1968 - 1972 Corvette: Service News: Rear Bow Lock Spring Replacement

Subject: Rear Bow Lock Spring Replacement

Model and Year: 1968 - 1972 Corvette Convertible

Date: January 1972 - Volume 44, Issue #1

Fig. 5—Corvette Bow Lock Spring

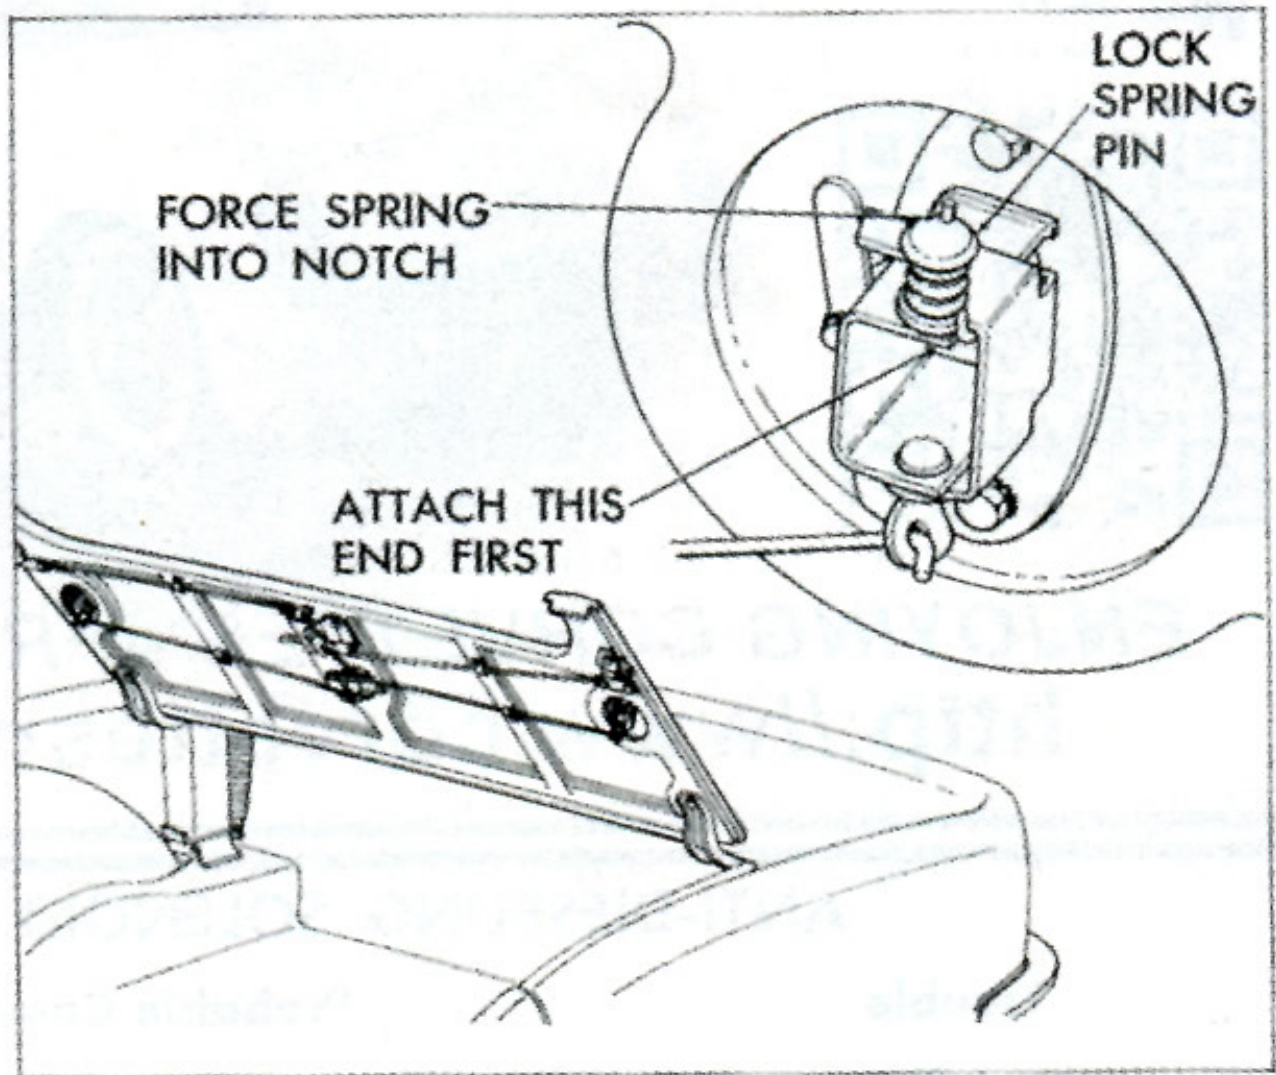
Folding top rear bow lock springs have been released as service parts for 1968 thru 1972 Corvette convertible models. Previously, the springs were replaced only as part of the left or right side bow lock assembly.

In the event of a bow lock spring failure, install Spring - Part No. 3942773 (left side) and/or Spring - Part No. 3942774 (right side) as follows:

1. Thread the spring, hooked end first, onto lock spring pin.
2. With catch in locked position, attach hooked end of spring into housing body (Fig. 5).
3. Using needle nose pliers, force the straight end of spring into the holding notch of pin.
